Planning and Zoning Meeting. June 17, 2026, considering variances and ordinance changes.
Document provided by Lynne Benton, P&Z member.

Agenda Item 7.

Discussion/Recommendation for Approval of the Installation of a 20,000-Pound Elevator-Style Boatlift on a canal with less than 60 feet of navigable waterway at the property located at 230 15th Circle. (pp. 5-14)

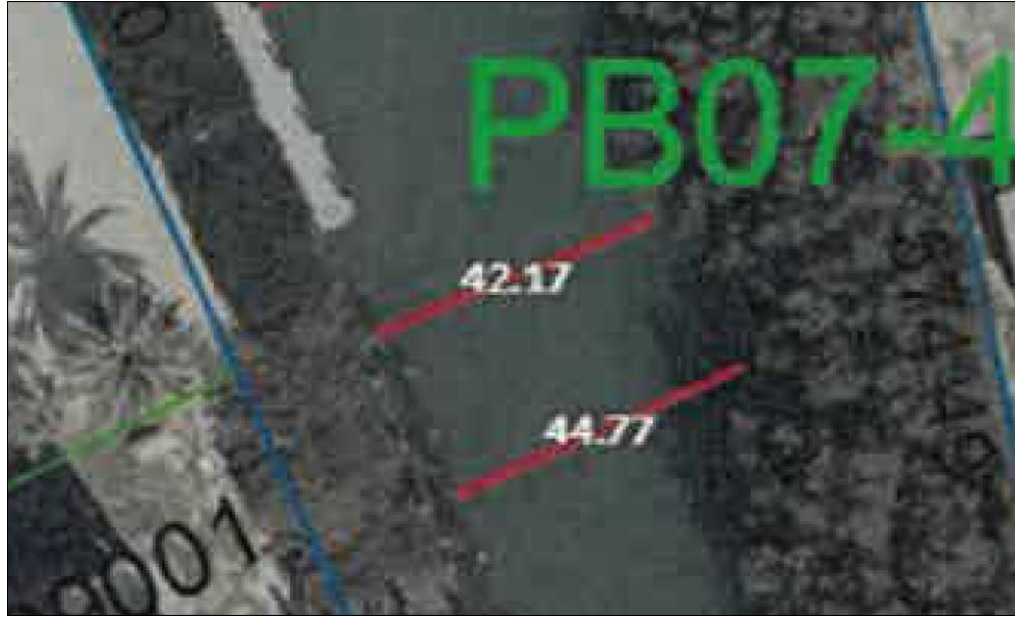
6. Lift and dock appear to extend 16 feet into the canal (from the middle of seawall to middle of dock post (5 feet) to edge of lift (11 additional feet)).

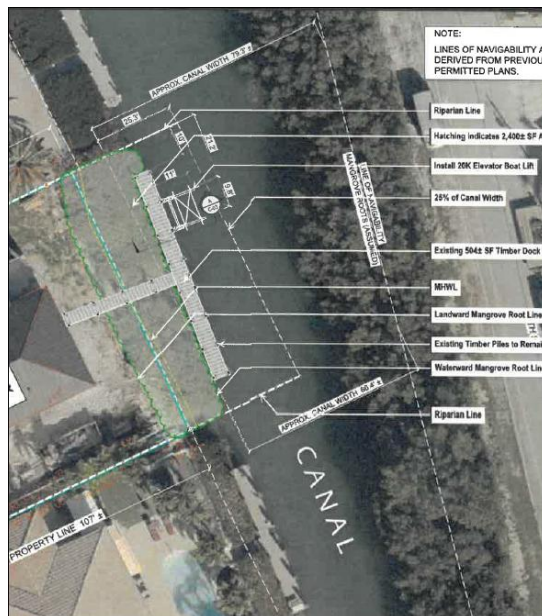
7. Widest navigable waterway, not including the dock or boat lift, appears to be about 50 feet. Building official report, p. 11. The 45 feet distance appears to stop at the outside pilings for the dock.

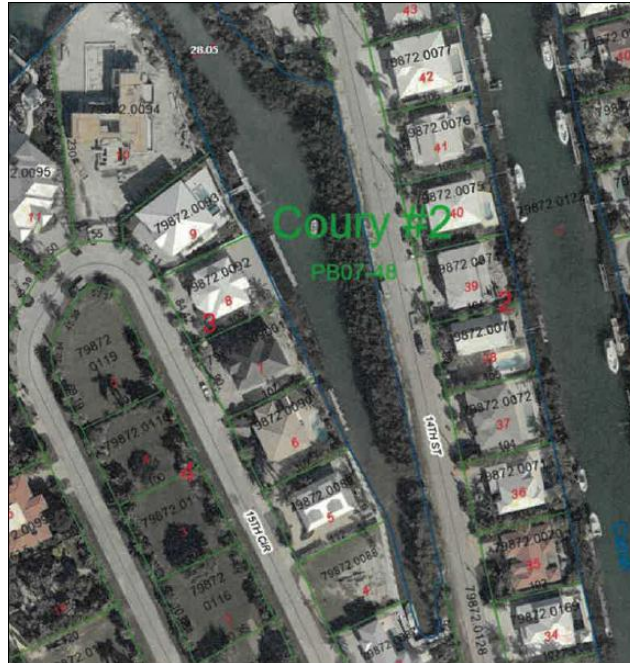
8. The resulting canal width with the dock and lift installed appears to be about 34 feet (45 feet minus 11 foot boat lift) or 33 feet from the lift edge to the vegetation line. Building official states that **33 feet** of width is narrow, but still navigable. Building official report, p. 11.
